Evaluation of the report of Tokyo Electric Power Company regarding the leakage from the RO-3 contaminated water treatment facility desalination system (reverse osmosis membrane system) at Fukushima Daiichi Nuclear Power Station

15 April 2015

Nuclear Regulation Authority, Japan

Figure 4 Leakage situation in the RO-3 cornice house and leakage amount (extracted from the TEPCO report)

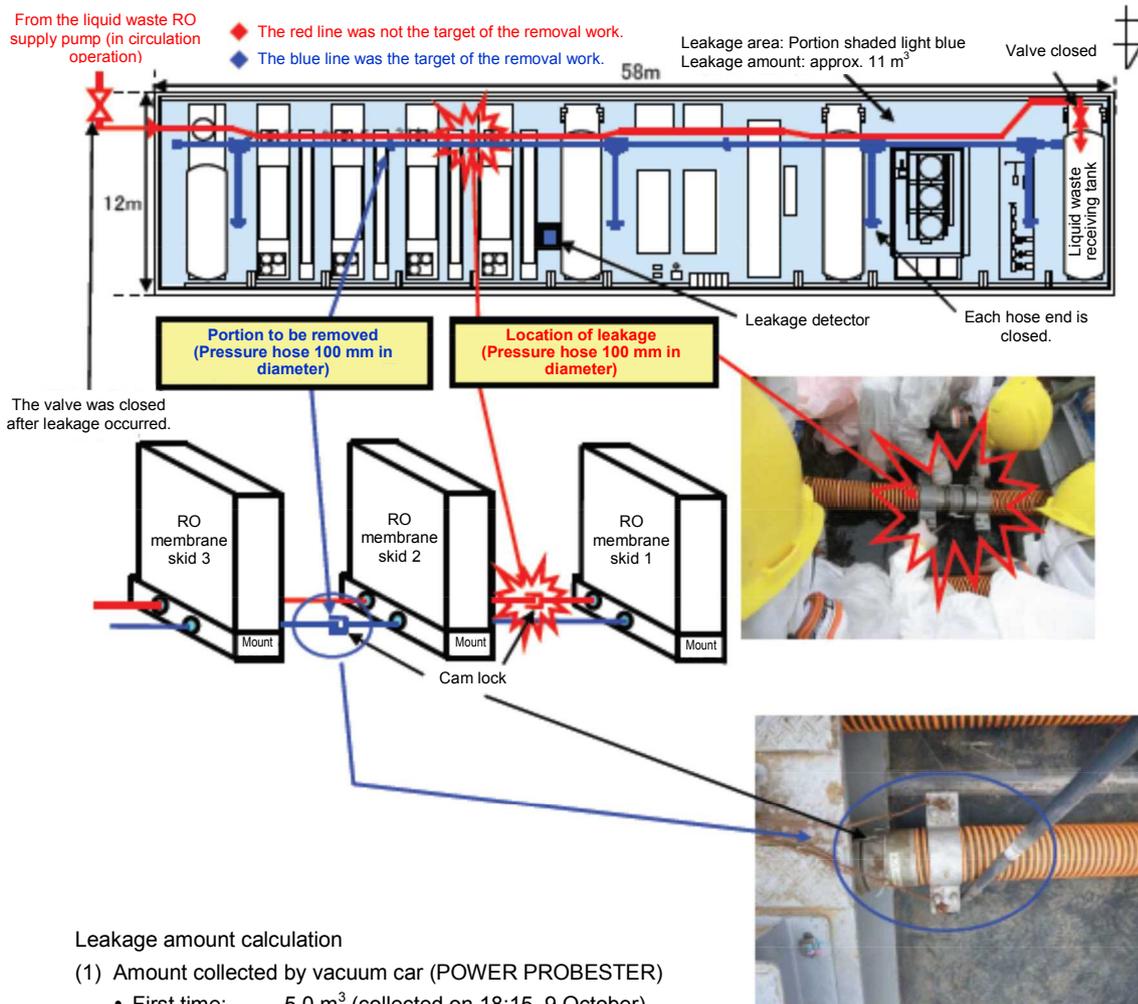
The worker who was replacing the pressure hose with PE piping as part of reliability improvement measures misidentified an adjoining pressure hose as being the one subject to replacement and mistakenly removed a cam lock with no identification marking (refer to Figures 4 and 5).

The adjoining pressure hose from which the cam lock was mistakenly removed was in operation and had water passing through it; therefore, leakage occurred. The leakage was stopped by shutting down the waste liquid supply pump and reconnecting the cam lock.

Although the amount of leaked water was approximately 11 m³, it remained inside the cornice house dike and did not spread outside the dike. In terms of total beta, the radioactive concentration was 3.4×10^7 Bq/L, while the total amount of radioactivity was approximately 3.7×10^{11} Bq.

Based on the fact that the misidentification of the cam lock was due to the failure to require identification markings at the time of procurement, a requirement that identification markings be added and checked by the work supervisor has been stipulated in the additional specifications for work.

Based on the fact that the leakage occurred because the adjoining pressure hose from which the cam lock was mistakenly removed was in operation and water was passing through it, a review of the safety assessment guidelines has been conducted so that safety measures (such as conducting risk assessment and removing risks before starting work) are taken.

Figure 5 Situation regarding cam lock removal while removing the pressure hose to replace it with PE piping (extracted from the TEPCO report)

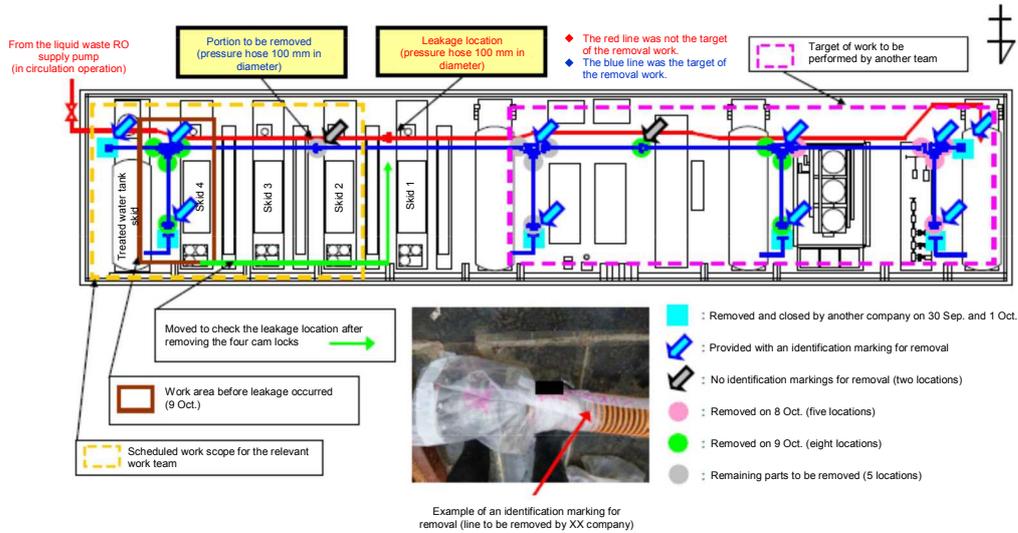
The leakage was caused by performing the work without sufficient safety measures such as isolation as well as failing to provide clear identification markings.

The NRA concludes that these countermeasures will be effective in reducing the leakage risk if implemented appropriately.

Figure 6 Work and assignment situation at the site before and after leakage occurred (extracted from the TEPCO report)

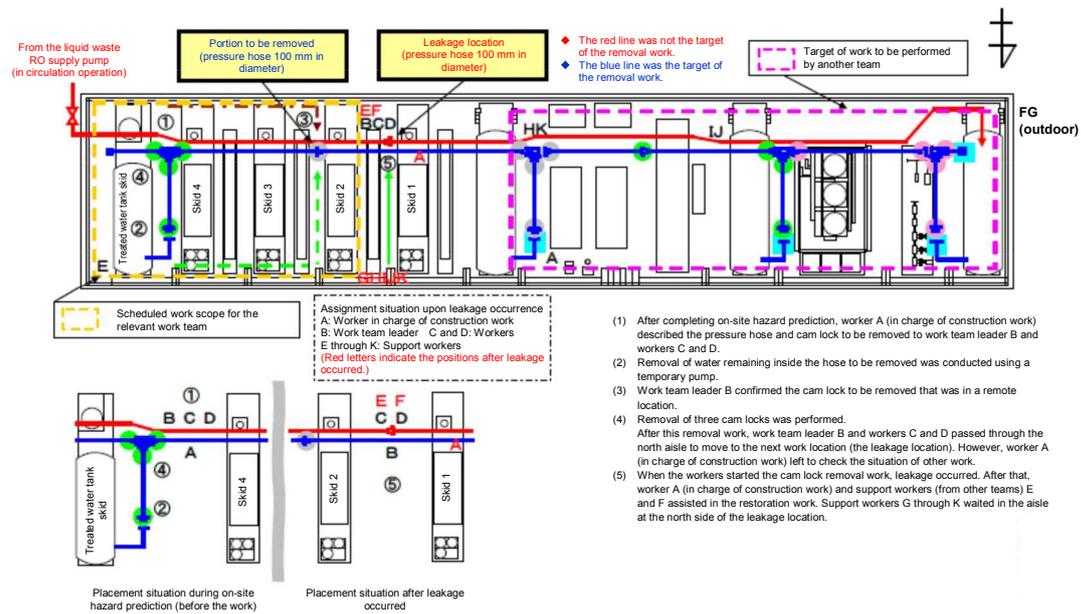
When contamination occurred from the cam lock, the workers did not immediately leave the site but instead performed water cut-off work without sufficient equipment. For this reason, six of the eleven workers were found to have bodily contamination below the neck (refer to Figure 6 and Table 1). For five of these six workers who were wearing anoraks, contamination may also have occurred when taking off the anoraks because they did not first remove the contaminated water and other substances on the anorak surface.

Bodily contamination occurred because the workers did not implement sufficient radiation protection measures; for example, they performed water cut-off work without sufficient equipment and did not remove contaminated water and other substances on their anoraks when removing the anoraks.

Based on the assumption that bodily contamination of the workers occurred because they performed water cut-off work without sufficient equipment and did not first remove contaminated water present on their anoraks when removing the anoraks, measures to help workers sufficiently understand the rules have been implemented, including dissemination of requirements regarding radiation protection at meetings as well as through the company intranet. The NRA considers these countermeasures to be reasonable.
